Re: WATERFORD SES UNIT NO. 3
TRANSMITTAL OF PSAR CHANGE REQUEST CH-3
FOR REVIEW AND APPROVAL

Enclosed please find PSAR change request CH-3, "Allowable Soil Bearing Pressure Prior to Recharging", for your review and approval.

Allowable Soil Bearing Pressure Prior to Recharging

SOIL PRESSURE TIME-HISTORY DIAGRAM

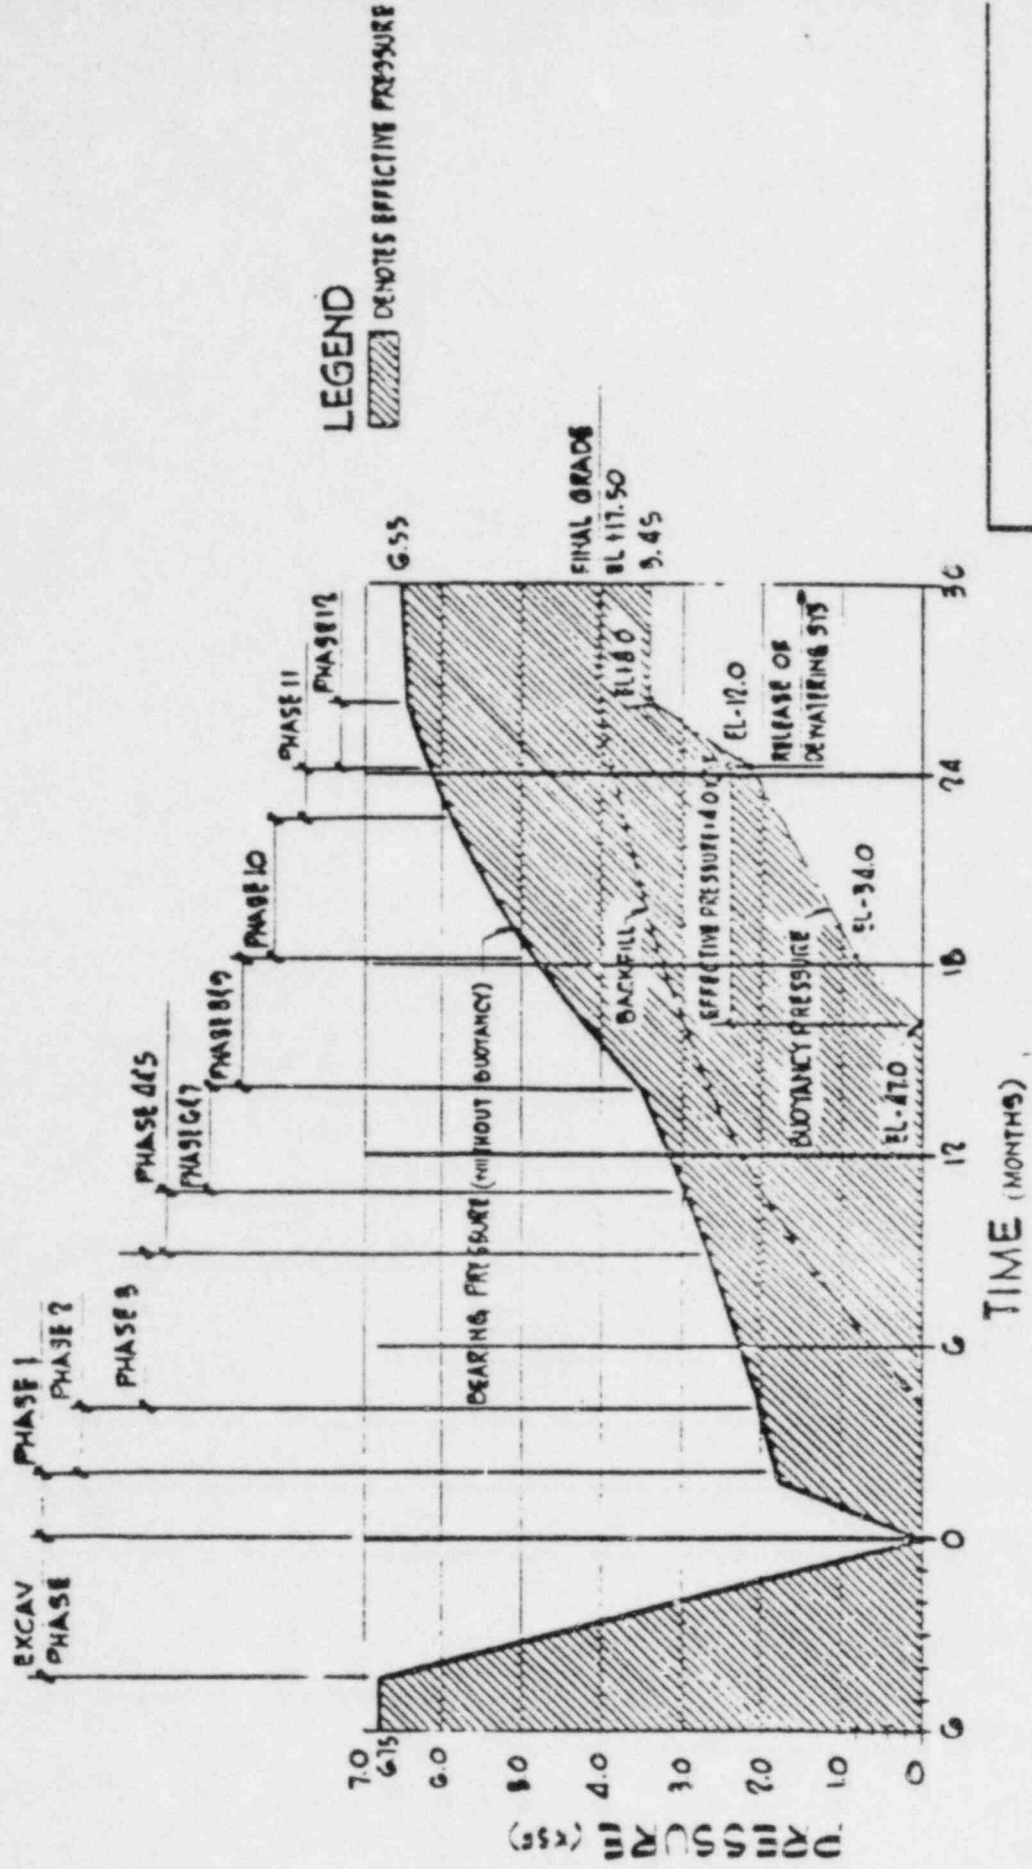
Change: During the concrete construction phases, the pressures begin to increase and continue until a stress of 4500 lb per sq. ft. has been applied.

Notes: Any reference to Figure 2.D-5 concerning the previous allowable stress of 4000 psf will be similarly changed to 4500 psf in the forthcoming FSAR.

The recompression of the foundation soils have been progressing at a slower rate than anticipated, primarily due to the long and extended period of partial excavation and final excavation. In order to increase the rate of recompression the allowable bearing pressure prior to recharging should be increased from 4000 to 4500 psf. The response of the foundation soils are being monitored continuously and the time and magnitude of loading prior to recharging will be predicated on the actual recompression being experienced. The objective is to essentially recompress the foundation soils to their preconstruction condition; namely, overload the soils until the heave experienced during the excavation phase has been compensated by induced settlement (recompression).

This additional effective stress is still safety within the maximum allowable soil bearing pressures of 15,000 psf. The factor of safety against any bearing failure under the increased loading is still in excess of 3.
